UNITED STATES PATENT AND TRADEMARK OFFICE

APPLICATION NO.	FILING DATE	FIRST NAMED INVENTOR	ATTORNEY DOCKET NO.	CONFIRMATION NO.
09/883,851	06/18/2001	Bogdan C. Maglich	HIENER.1CPC1CP	9955
20995	7590	12/23/2003	EXAMINER	
KNOBBE MARTENS OLSON & BEAR LLP			KEITH, JACK W	
2040 MAIN STREET			ART UNIT	
FOURTEENTH FLOOR			PAPER NUMBER	
IRVINE, CA 92614			3641

Office Action Summary

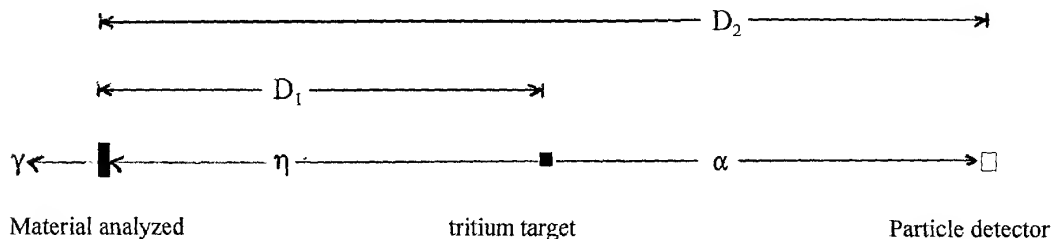
Applicant argues the 102(b) rejection of Sawa citing that the Sawa reference does not disclose the claim limitations "second subatomic particles at a target position which is a first distance from the material/chemical substance to be analyzed" and the limitation "a particle detector being a second distance from the target position, the second distance larger than the first distance".

The examiner disagrees. Sawa sets forth a prior art system capable of meeting applicant's claimed inventive concept. Note that prior art referred to in a reference patent may be used for what it fairly teaches. See In re Fortess and Schoeneberg, 152 USPQ 13. That is a particle generator (i.e., tritium target) generating first subatomic particles (neutrons) and second subatomic particles (alphas). The first subatomic particles (neutrons) and second subatomic particles (alphas) being emitted in opposite directions. These particles, both first and second subatomic particles, are generated at a first distance from the tritium target to the material to be analyzed (i.e., suitcase). A particle detector (i.e., a second subatomic particle (alpha) detector) is located near the tritium target. Therefore since it is well established that neutrons and alpha particles are emitted in opposite directions the distance from the particle detector of the Sawa prior art must be greater than the distance between the material to be analyzed and the tritium target. That is the particle detector must lie in the path of the second subatomic particles

(alphas) in order to detect said second particles. That is the Sawa prior art system sets forth a second distance (D_2) > first distance (D_1). See below:

Referring now to the elected embodiment of figures 1-3 of Paper no. 9. Figure 1 clearly shows the claimed distances as being the same as those set forth in the prior art system of Sawa. Figure 1 shows a particle generator (18) generating first subatomic particles (neutrons)(14) and second subatomic particles (alphas) (16). The first subatomic particles (neutrons) and second subatomic particles (alphas) being emitted in opposite directions. These particles, both first and second subatomic particles, are generated at a first distance from the target to the material to be analyzed (i.e., suitcase). A particle detector (i.e., a second subatomic particle (alpha) detector)(28) is located near the tritium target. Thus, as in the Sawa prior art system applicant's particle detector is also near the target; however, this is not the claimed nor intended relationship in question. The relationship in question is the distance from the analyzed material to either the target or the particle detector. The prior art system of Sawa meets the claimed inventive concept.
